Subject: Request for Individual Permit Modification for NC 16 from north of SR
1386 in Lincoln County to North of SR 1895 in Catawba County. Federal
Aid Project No. STP-F-24-1(34) State Project No. 8.1830501. \$475.00
Debit work order 34383.1.5. TIP Project No. R-2206C.

Reference: USACE Individual Permit dated October 7, 2004, Action ID 200420899.
NCDWQ Water Quality Certification dated September 21, 2004,
Individual WQC No. 3476.

Killian Creek Bank Stabilization, Station 199+30

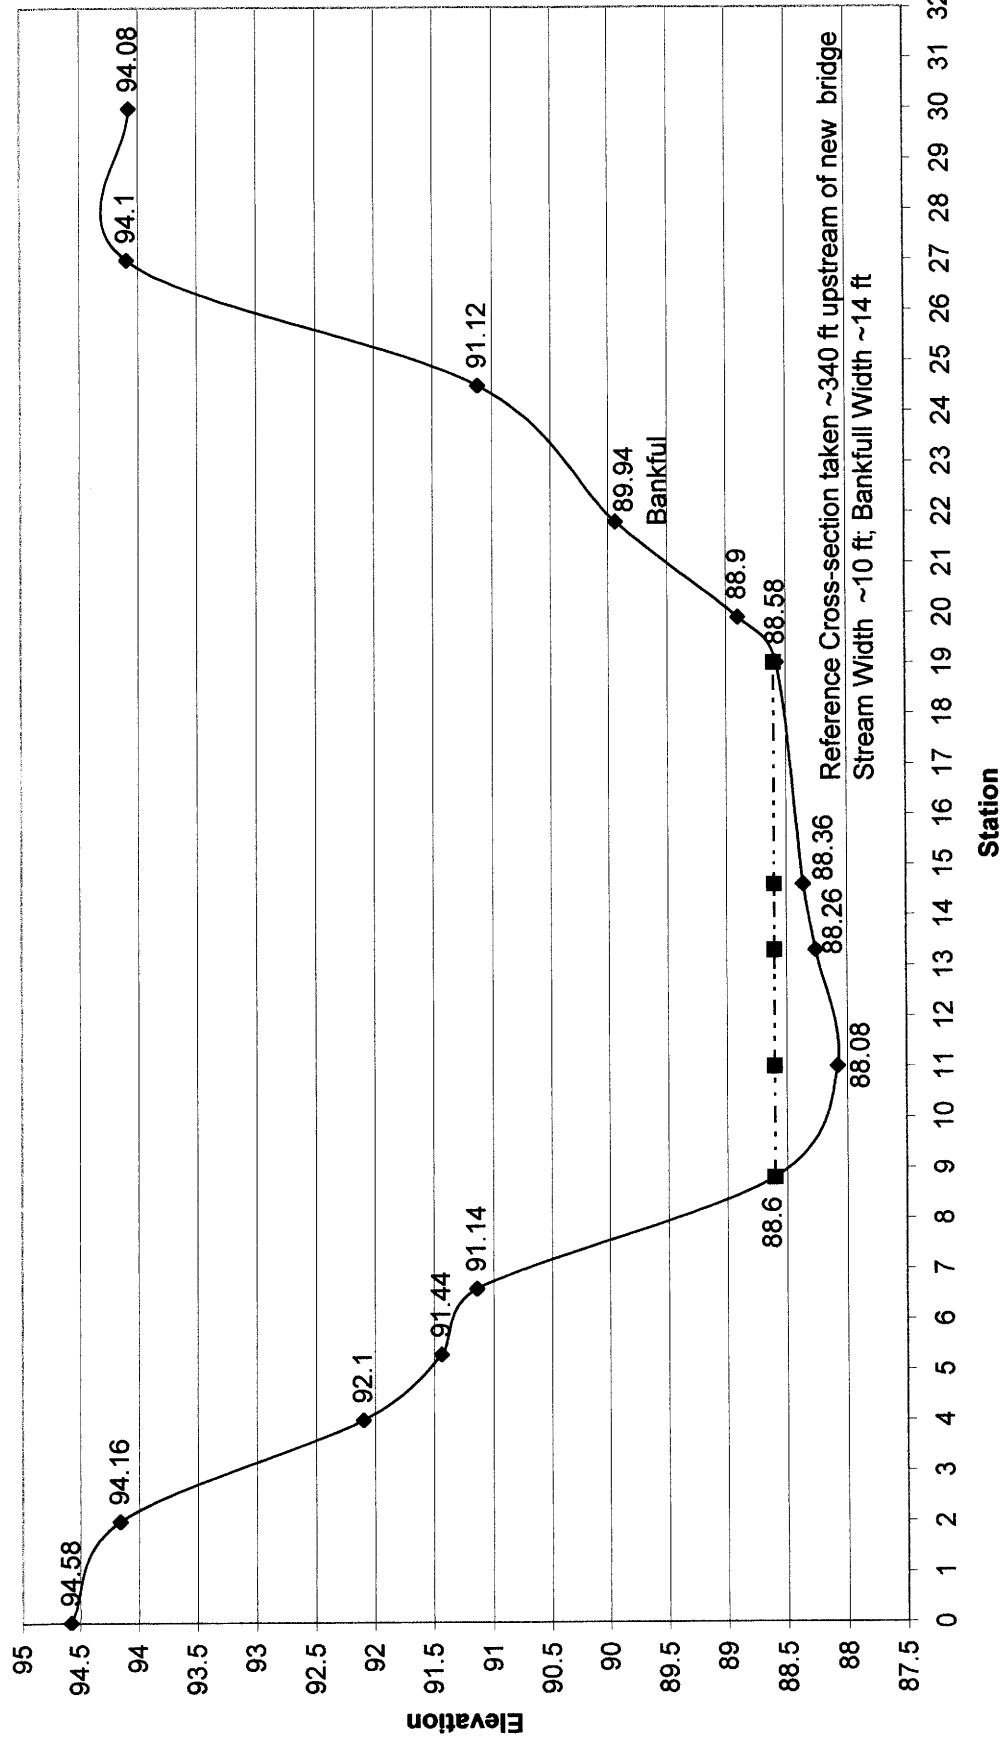
- (1) Killian Creek Bridge requires bank stabilization at the new bridge supports due to erosion (see enclosed photo). Rock has already been installed in a "stair-step" fashion from existing water's edge to top of bank. Stream width dimensions and bankfull width dimensions maintained based upon upstream reference cross-section (enclosed). The permanent impacts for this are 70 linear feet.
- (2) Unpermitted wetland fill impacts in the vicinity of permit site 17C total 0.09 acre.
- (3) Reed Creek Bridge requires bank stabilization at the new bridge supports due to erosion (see enclosed photo). Rock will be installed in a "stair-step" fashion from existing water's edge to top of bank. Stream width dimensions and bankfull width

dimensions maintained based upon upstream reference cross-section (enclosed). The permanent impacts for this are 65 linear feet.

PROJECT REFERENCE NO. R-2206C		SHEET NO. 10	
ROADWAY DESIGN ENGINEER NORTH CAROLINA PROFESSIONAL SEAL 15356 ROYAL DAVID ALLEN 9-2-04		HYDRAULICS ENGINEER NORTH CAROLINA PROFESSIONAL SEAL 1160 DOUGLAS BAUNDERS 7/30/04	
CONST. REV.		R/W REV.

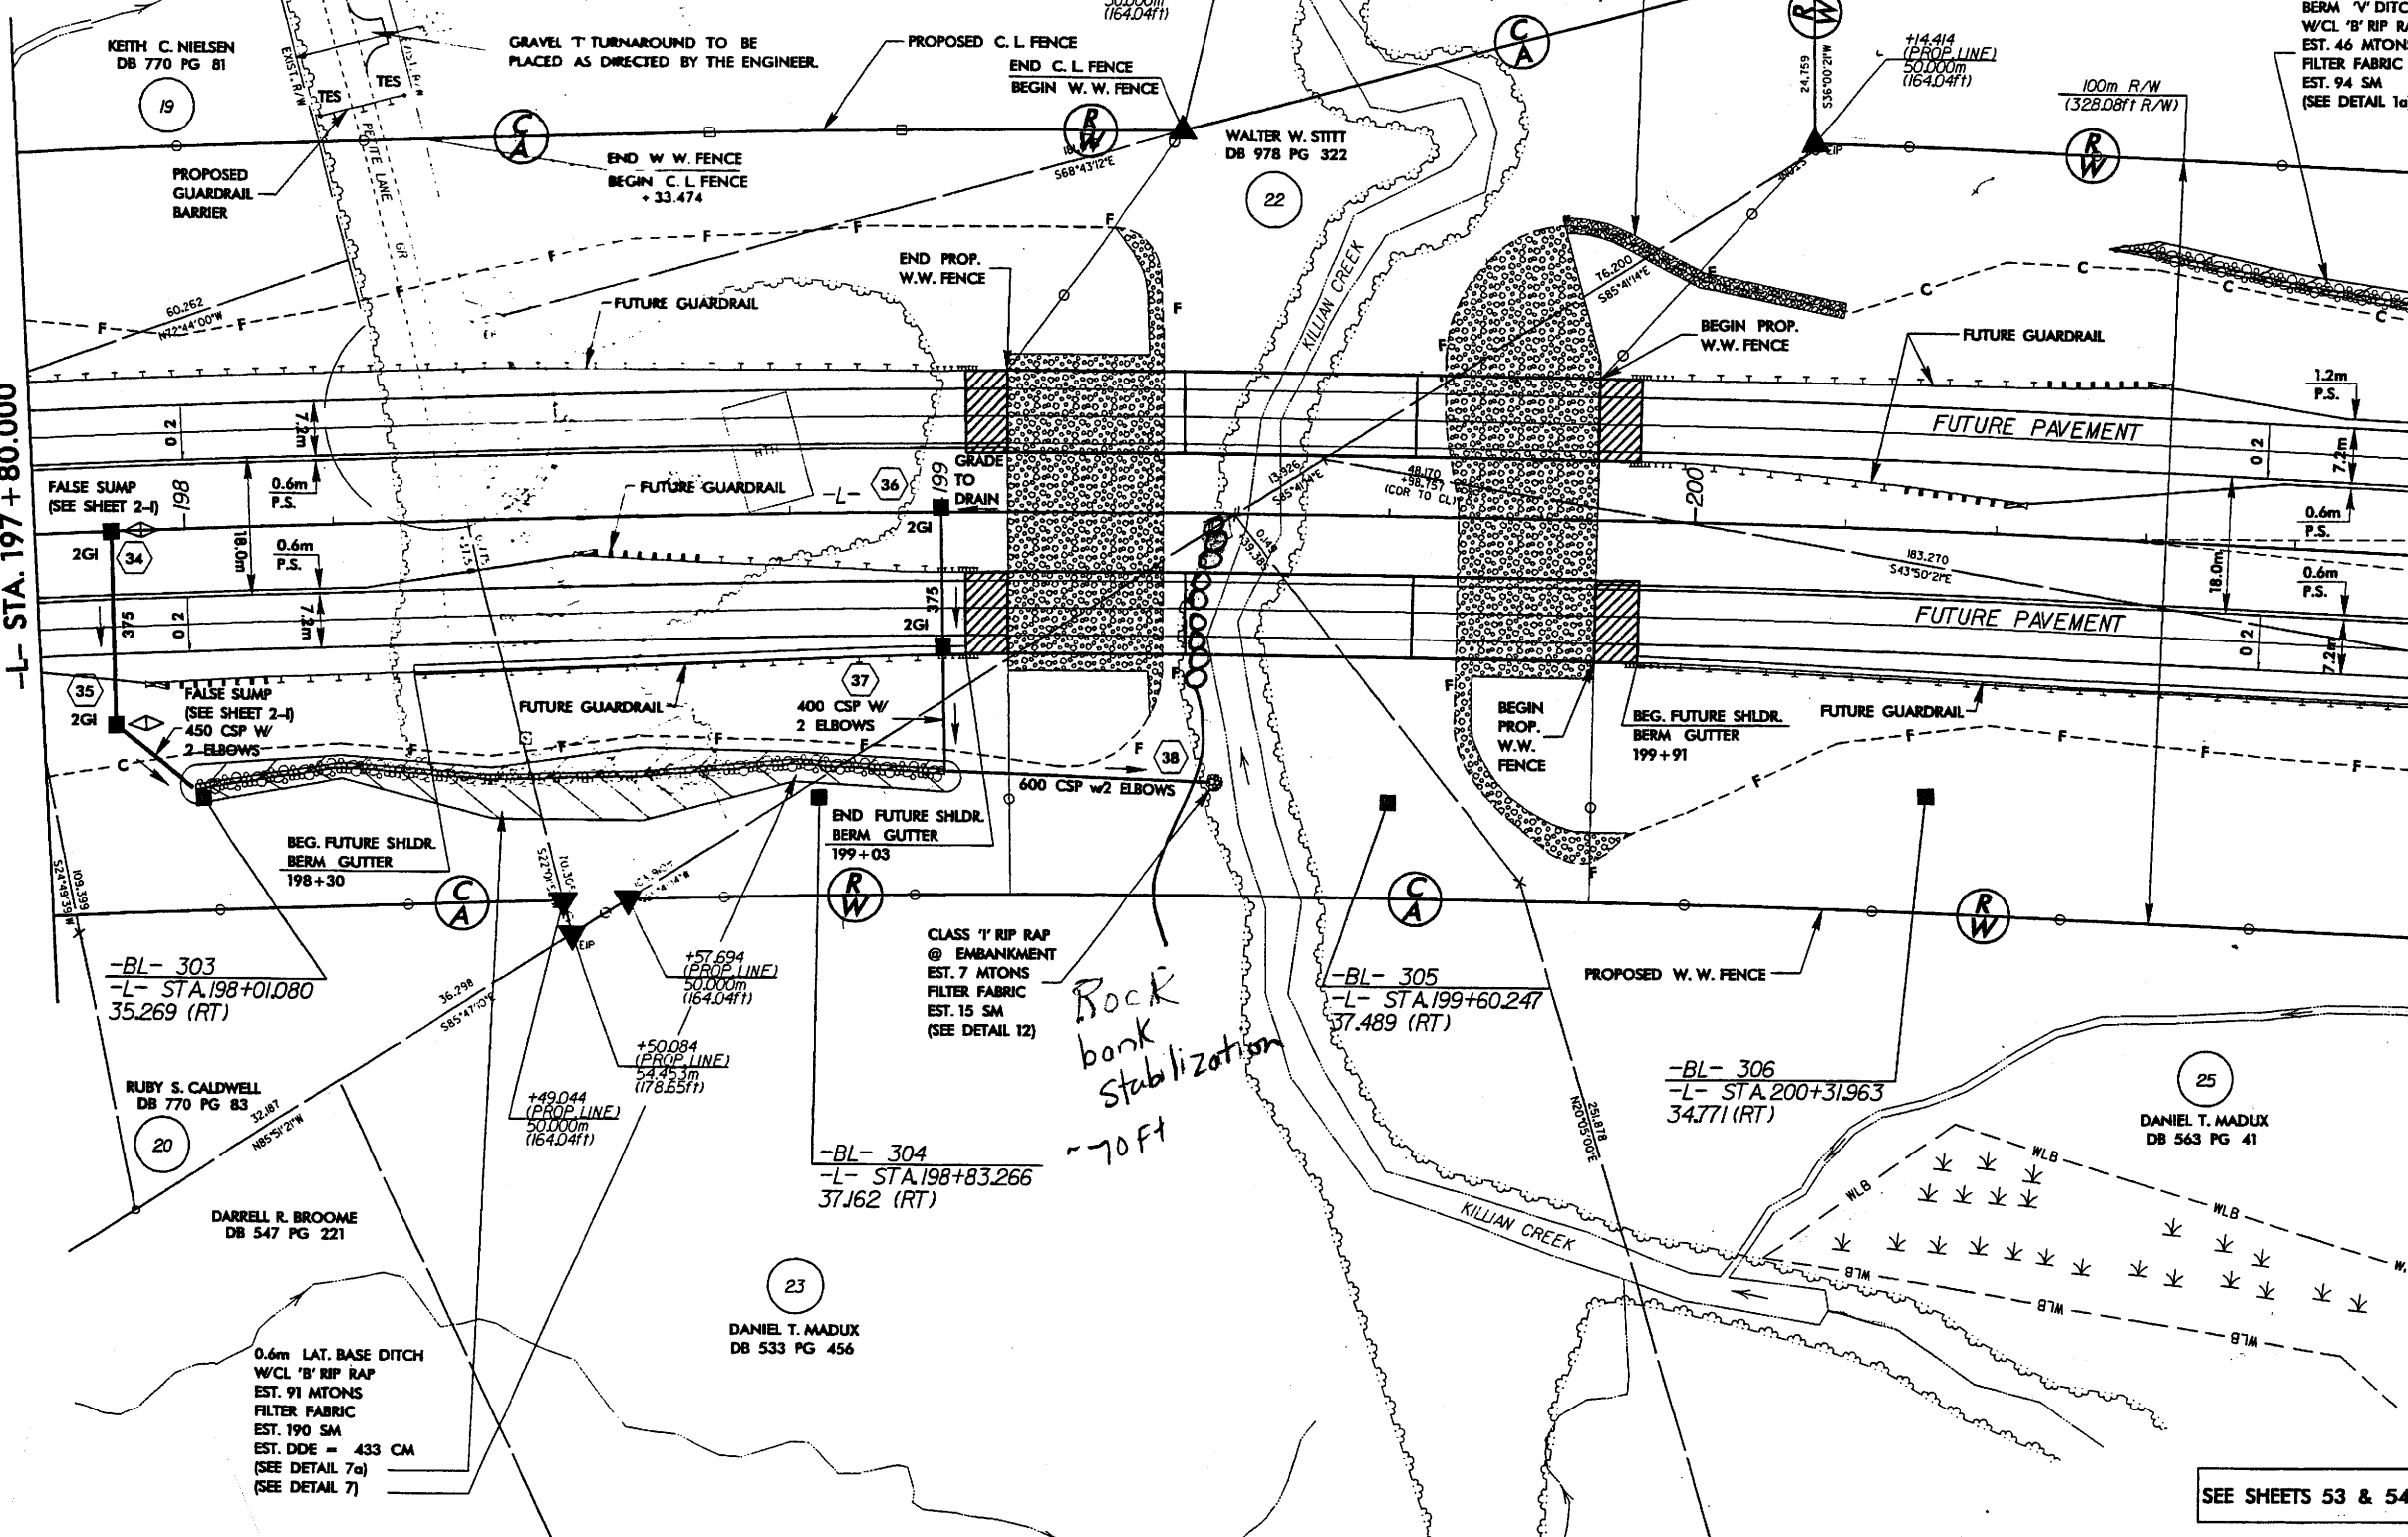
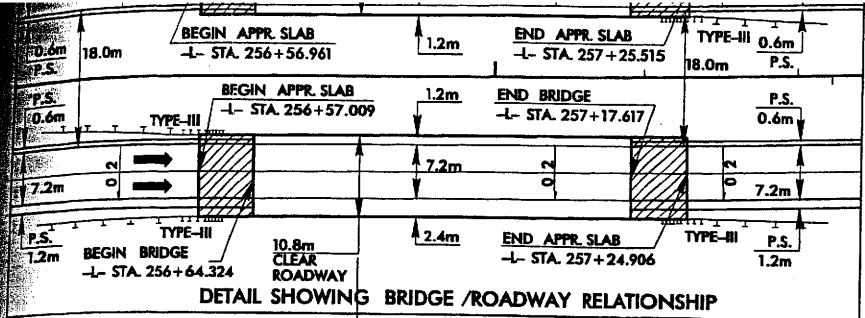
Rock bank stabilization
~70 FT

**PLAN VIEW
SITE 15C**

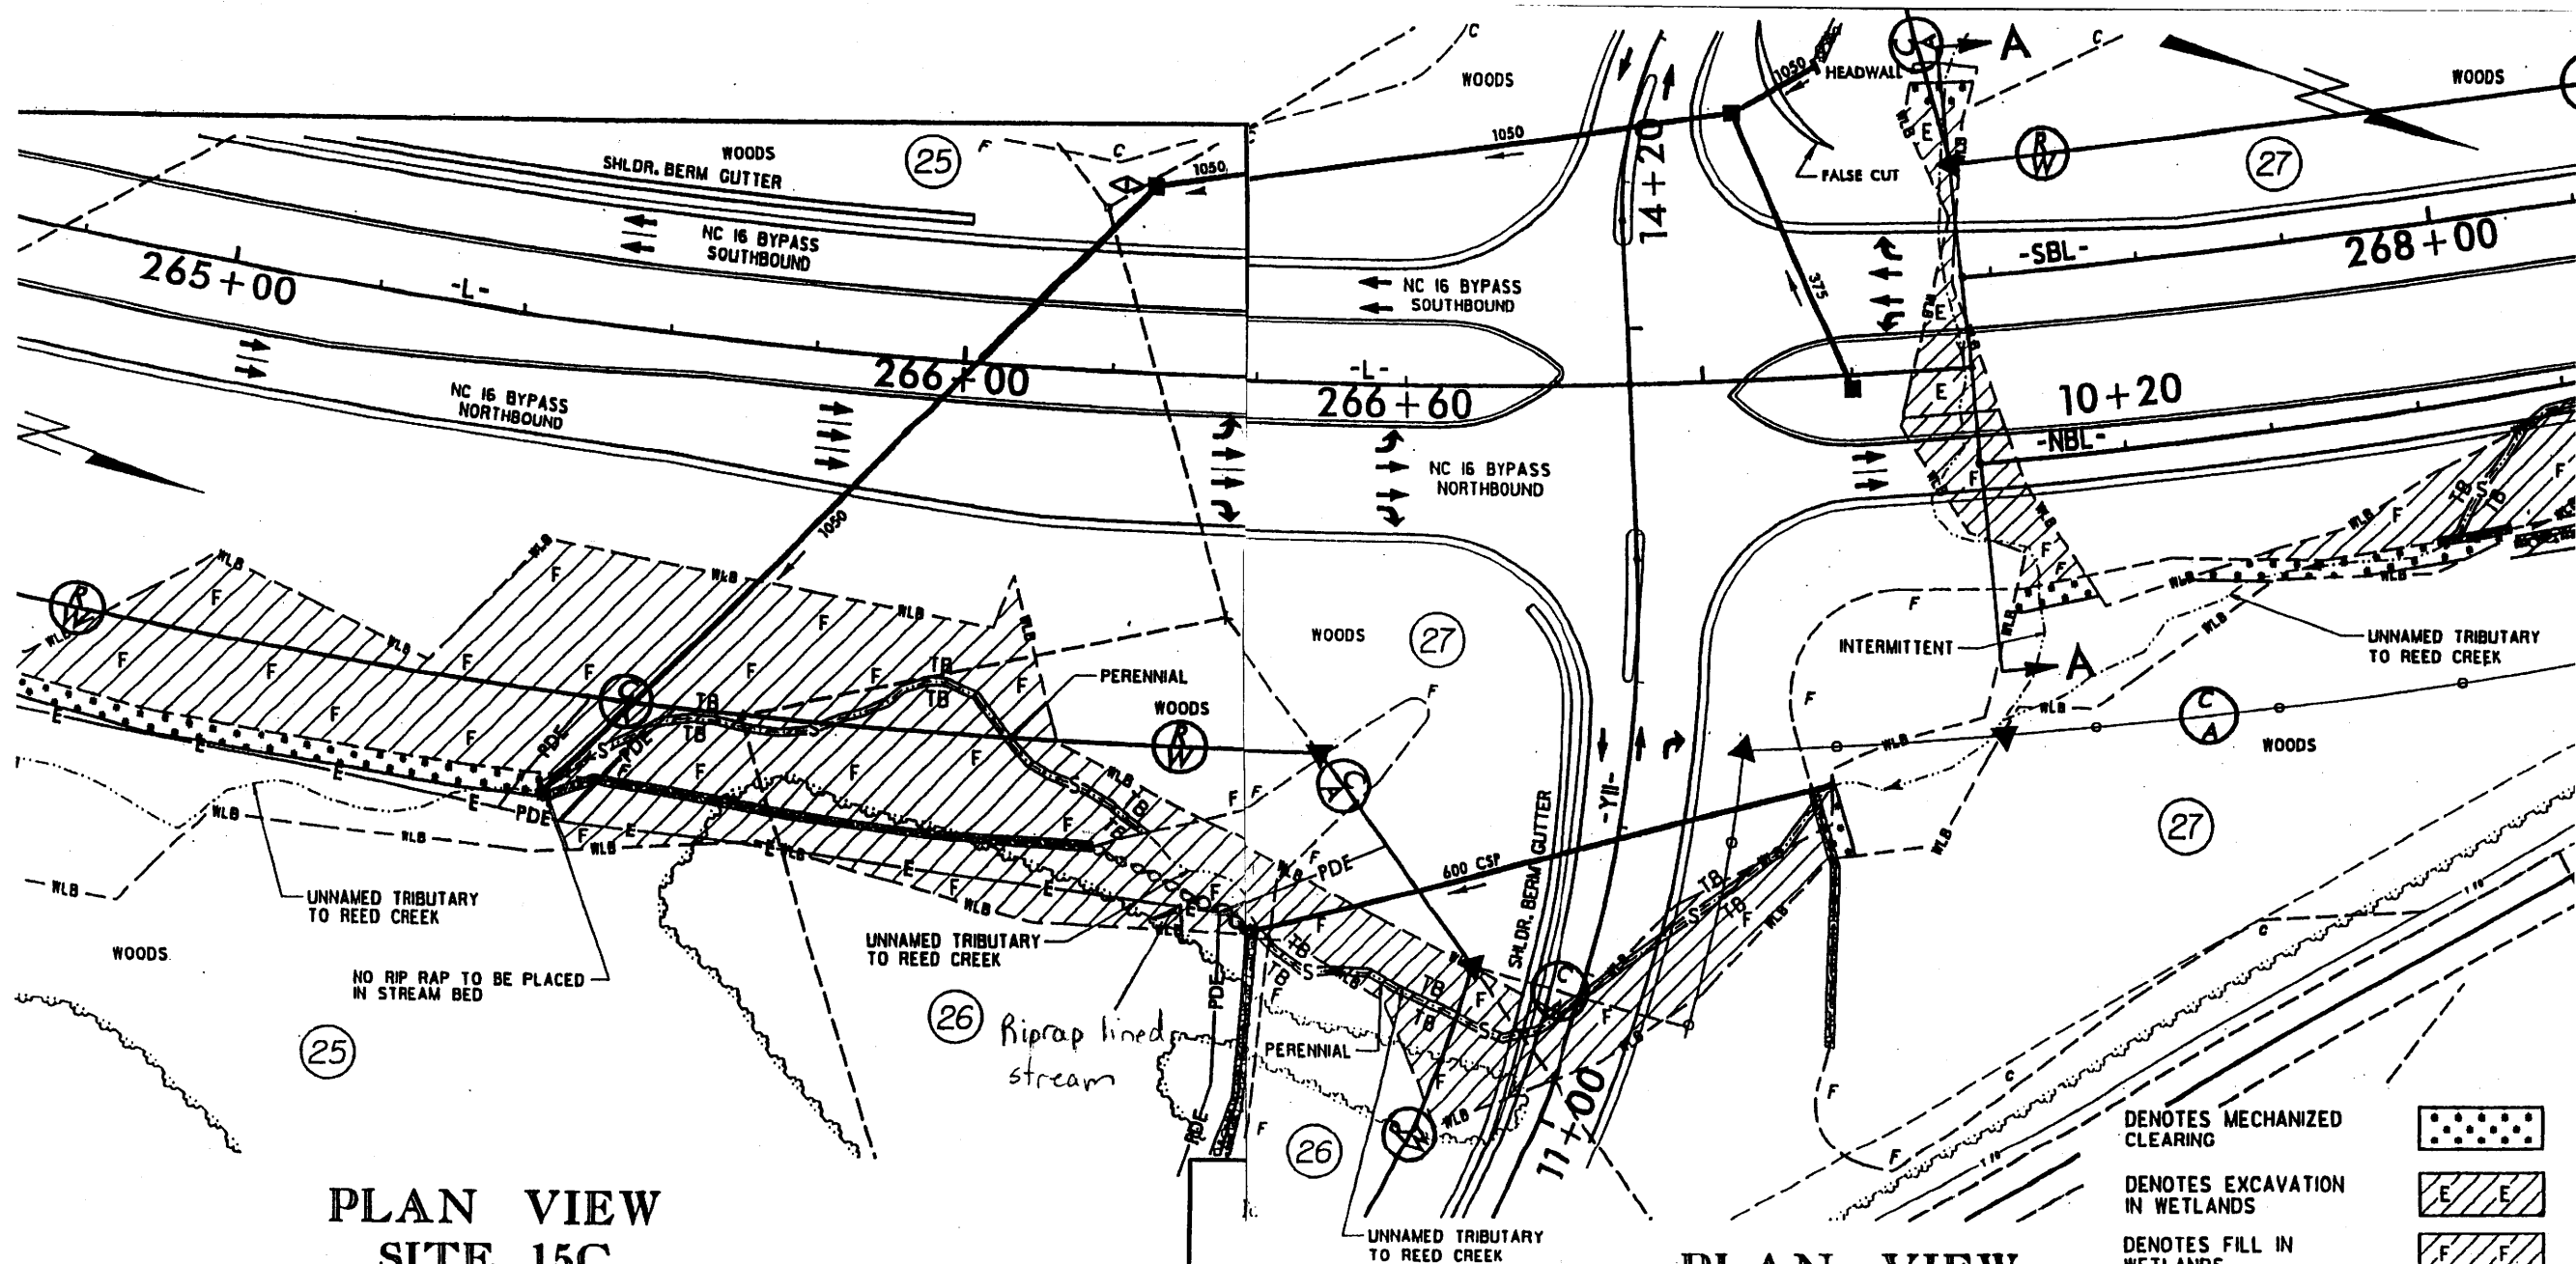
- (4) A riprapped ditchline will extend from the 600 CSP to the toe protection ditchline to divert flow. The permanent impacts for this are 90 linear feet.
